Safety Defect and Noncompliance Report Guide for Vehicles
PART 573 Defect and Noncompliance Report⁽¹⁾

05V-250
(15 pages)

Make(s): ALPINE and AVALANCHE Model Years Involved: 2005 & 2006 Model(s): AC34201, AC36201, AC36202, AC36301, AC38301, AC40301, AC40302, AC40401, ACA40301

VANSCO VMM 2820 Module Change Out Procedure

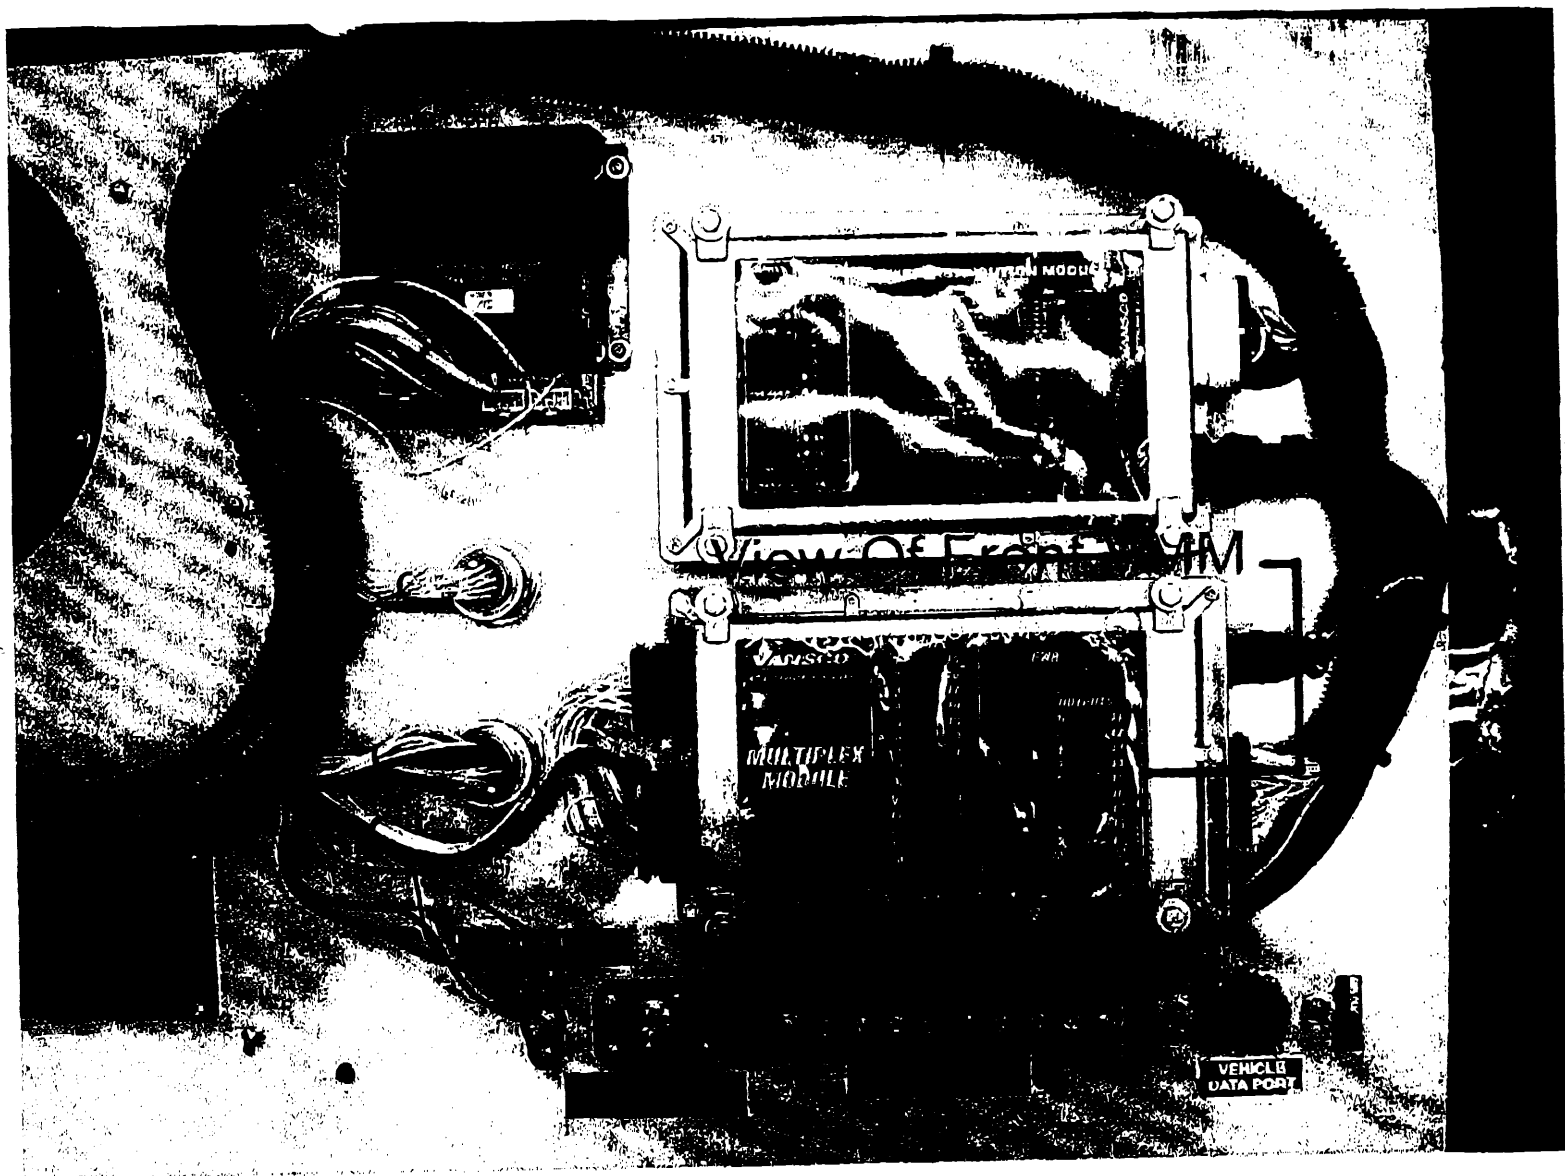
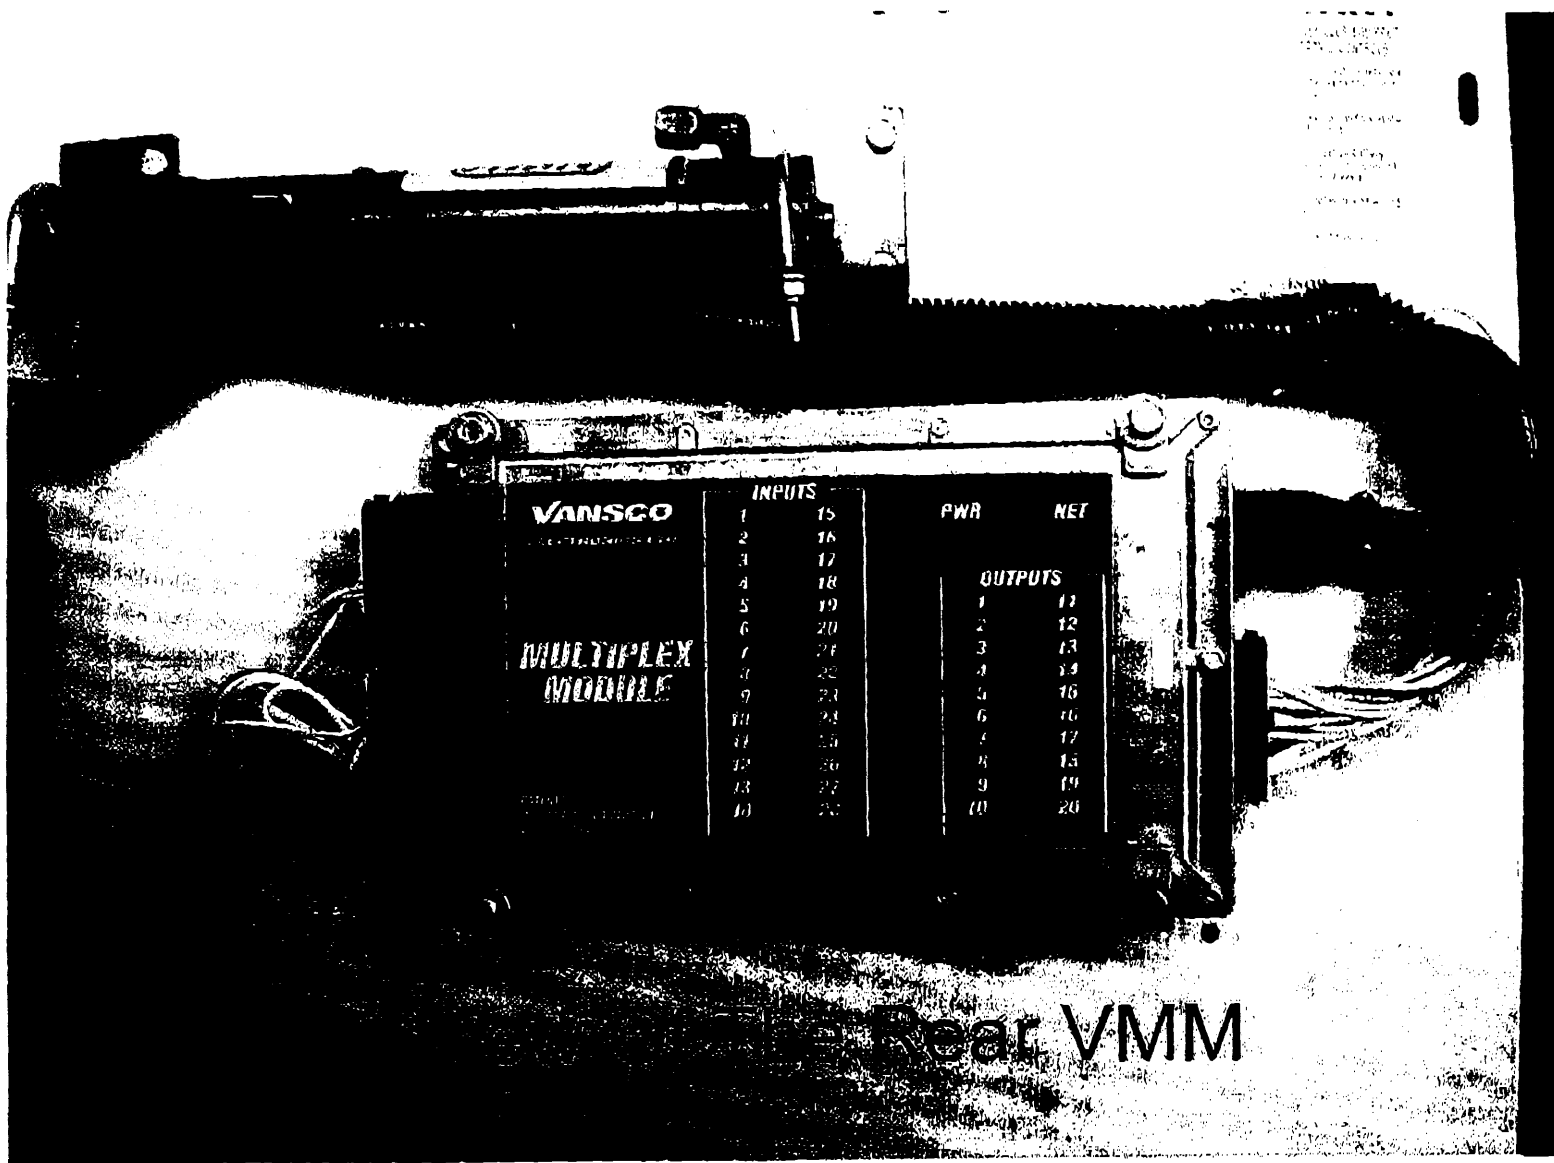
5. Check the date code on the VMM and ensure it falls between 2004-04-15 and 2005-03-29 inclusive, and that no yellow circular sticker exists (refer to picture). If the date code falls within the range, and no yellow sticker exists, proceed with swapping the module.

6. Unplug the wiring harness connectors from the rear VMM that is mounted on the chassis panel (Picture)
7. Unbolt the VMM from the chassis panel and install the revised VMM. Reattach the wire harness connectors.

11. Remove the kick panel under the dash board in front of the passenger seat to expose the front VMM (Picture)
12. Turn off chassis disconnect
13. Check the date code on the VMM and ensure it falls between 2004-04-15 and 2005-03-29 inclusive, and that no yellow circular sticker exists (refer to picture). If the date code falls within the range, and no yellow sticker exists, proceed with swapping the module.

14. Unplug the wiring harness connectors from the front VMM that is mounted behind the kick panel
15. Unbolt the VMM from the body panel. This operation will require two technicians. Install the revised VMM and reattach the wire harness connectors

Please Note: It is imperative that the connectors are all properly seated on the replacement modules. In particular, it is of special importance that the round power connector be given an extra twist to ensure it is secure. This is extremely important to ensure long problem free operation of the VMM Modules. If you have any questions or problems please call 7-866-567-4133
